Edwin I. Hatch Nuclear Plant – Unit No. 1  
Response to Request for Additional Information  
Regarding Fourth Interval Inservice Inspection Program

**Response to a Request for Additional Information  
Regarding Fourth Interval Inservice Inspection Program**

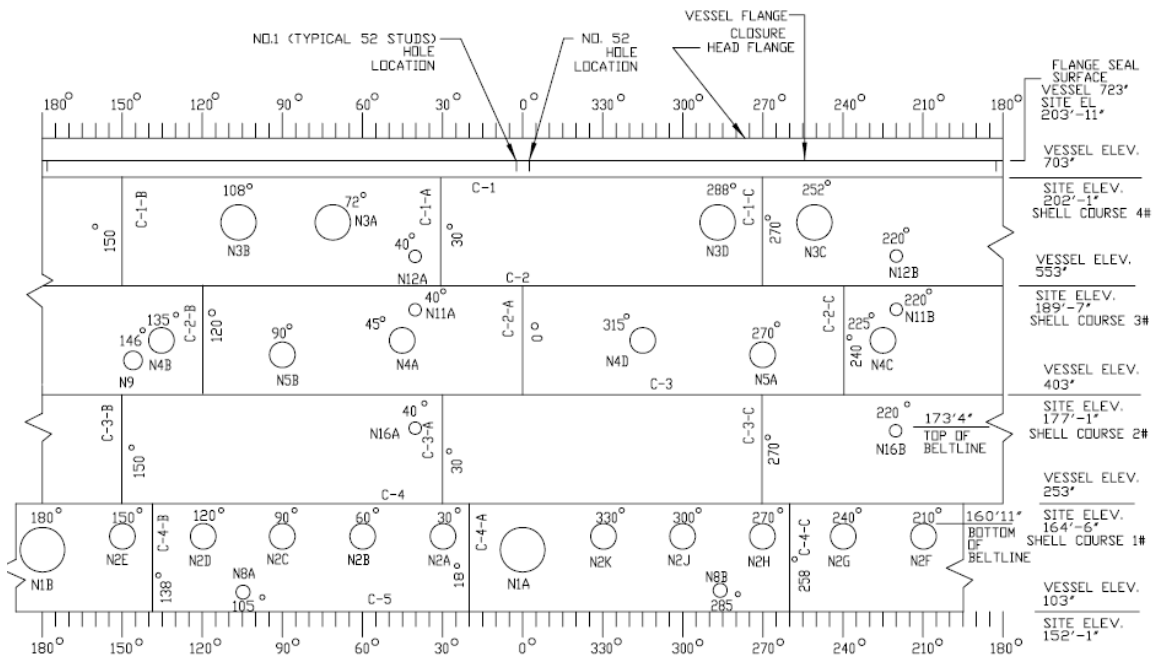
Discuss what efforts were taken to maximize weld examination coverage during the fourth 10-year ISI interval for the C-2-A weld. Discuss any additional tests or procedures that provide additional assurance regarding the structural integrity of the longitudinal welds listed in RR-01.

As shown in the figure below, the Hatch Unit 1 (HNP-1) reactor pressure vessel (RPV) shell was fabricated from four shell courses welded together. Each of these shell courses has three longitudinal welds; therefore, there is a total of 12 longitudinal shell welds. The reactor vessel was installed at Hatch such that the lower three courses of the vessel shell were located behind a concrete bio-shield.

For the 4<sup>th</sup> ISI Interval, as a result of the limitations observed during the previous ID examinations, in order to maximize weld examination coverage, SNC required the examination vendor to develop a lower profile scanning package that could fit between the vessel wall and the obstructions. This newly developed scanning package was used for the examinations covered by relief request RR-01 and its use significantly increased the examination coverage of the ID weld examinations. With the use of this new scanning package four welds had 90% or greater coverage, five of the welds had 77% to 83% coverage, and two of the welds had 69% to 71% coverage.

However, weld C-2-A, which is a lower fluence weld located in shell course 3, has a permanently installed steam dryer guide rod located in direct alignment with the weld. The distance between the inside of the guide rod and the RPV surface is only 4-inches and access beneath the rod could not be obtained, even with the newly developed lower profile scanning package. Additionally, as shown in Figure RR-01-01 of Relief Request RR-01, Core Spray piping (the “L” shaped piping) and the Feedwater Sparger (the horizontal piping) are mounted to the inside surface of the vessel wall. The proximity of this piping to the weld and the vessel wall prevented any scanning of the lower portion of the weld. Therefore, scanning was only performed on the upper portion of the weld.
